Service Manual

SB-C350

This supplement manual has been issued to inform you that the service manual for above model contains some incorrect information. Please kindly correct your service manual as follows.

CORRECTION

■ SCHEMATIC DIAGRAM

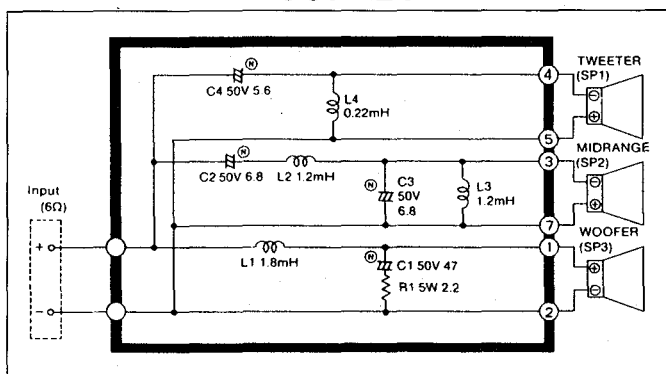
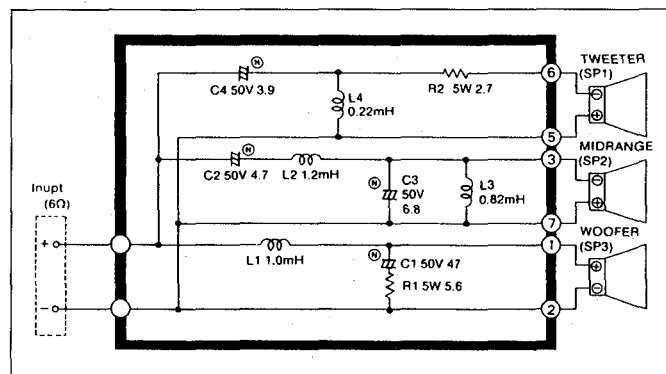
INCORRECT

CORRECT

Ref. No.	Change of Part No.		Part Name & Description	Remarks
	INCORRECT	CORRECT		
COILS				
L1	SLCSA182JE	SLCSA102JE	COIL, 1.0 mH	Change
L3	SLCSJ122JE	SLCSA821JE	COIL, 0.82 mH	Change
CAPACITORS				
C2	ECEA50Y6R8K	ECEA50Y4R7K	ELECTROLYTIC, 50 V, 4.7 μ F	Change
C4	ECEA50Y5R6K	ECEA50Y3R9K	ELECTROLYTIC, 50 V, 3.9 μ F	Change
RESISTORS				
R1	ERF5ZXK2R2	ERF5ZXK5R6	CEMENT, 5 W, 5.6 Ω	Change
R2	_____	ERF5ZXK2R7	CEMENT, 5 W, 2.7 Ω	Addition
ACCESSORY				
A1	SQFS472	SQFS438	INSTRUCTION MANUAL	Change
PACKING PART				
P1	SPG5743-2	SPG6270	CARTON BOX	Change
